Agenda Item 4

Committee Update Sheet – 29th November 2021

Vectos response to LCC Highways, National Highways, Network Rail and PROW

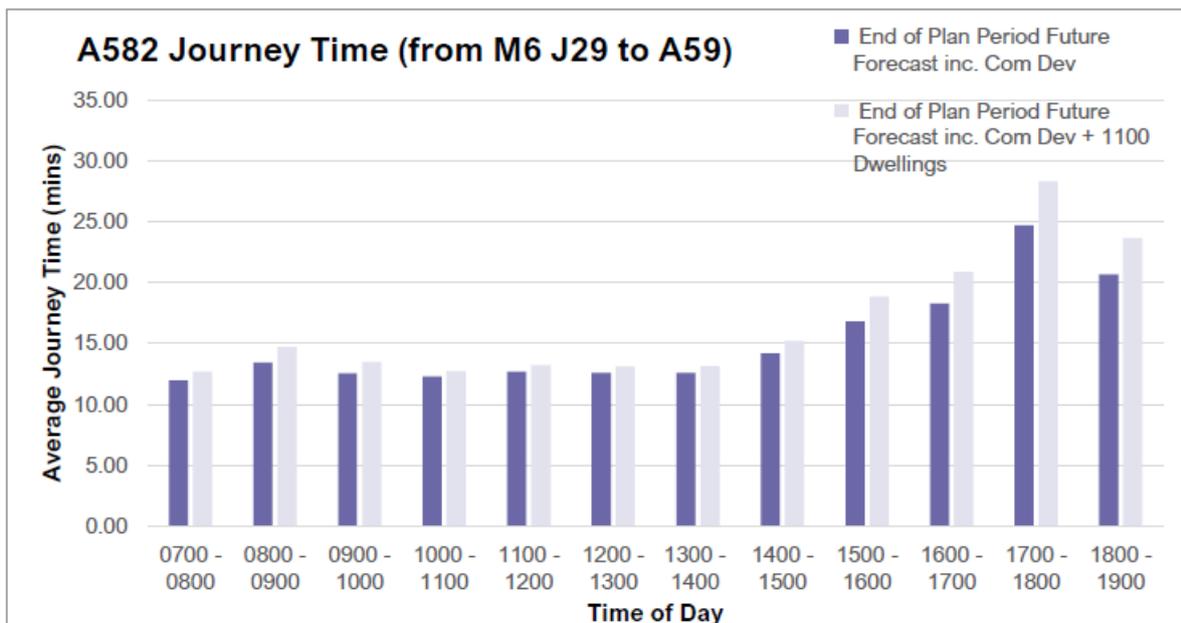
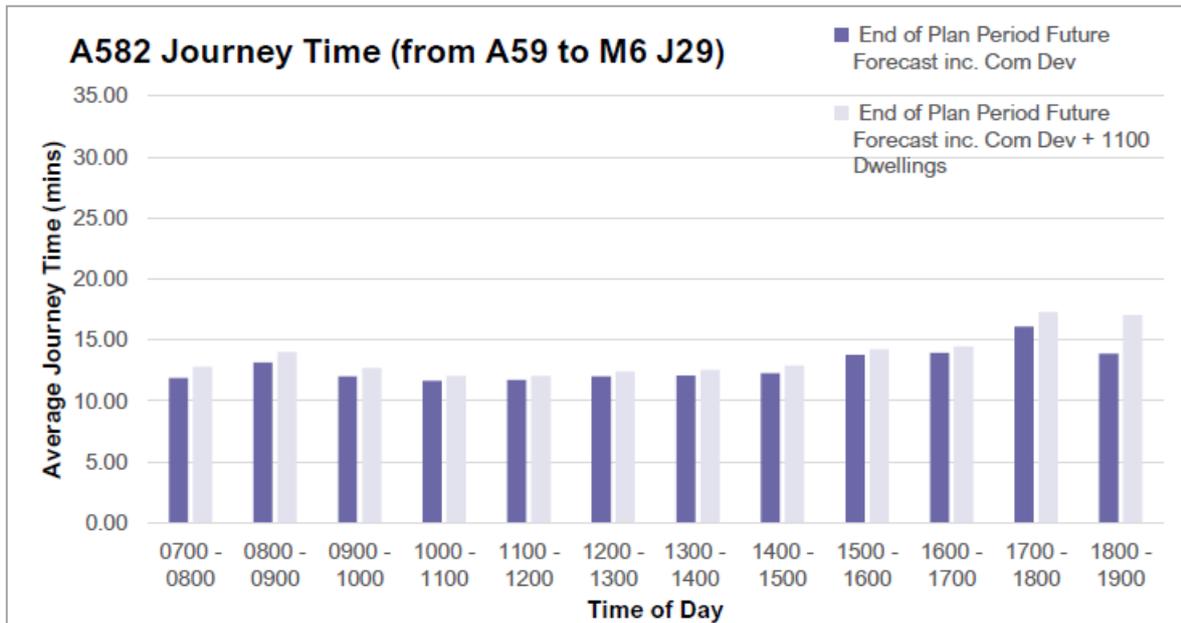
It has been noted by LCC Highways that the results of the modelling, due to what it considers a flawed modelling approach, are not accepted. Additional information has been requested regarding queue lengths on the network.

The TA includes the key elements for review, and highlighted that further specific information can be made available on request. Given the request, additional model results for the scenarios presented in the TA are attached within Technical Note 03 – Traffic Data and Modelling.

LCC Highways do question some of the traffic levels reported for certain parts of the network, particularly around the Strategic Road Network. However, it should be noted that the reported traffic flows will account for dynamic traffic rerouting in response to increases in congestion and inconvenience on the network. As such, it is not correct to simply assume that if traffic flows reduce on a certain part of the network that this demonstrates a flaw. In fact, this is where the use of micro-simulation as a more sophisticated traffic modelling tool allows for a more informed judgement to be made rather than relying on individual junction models.
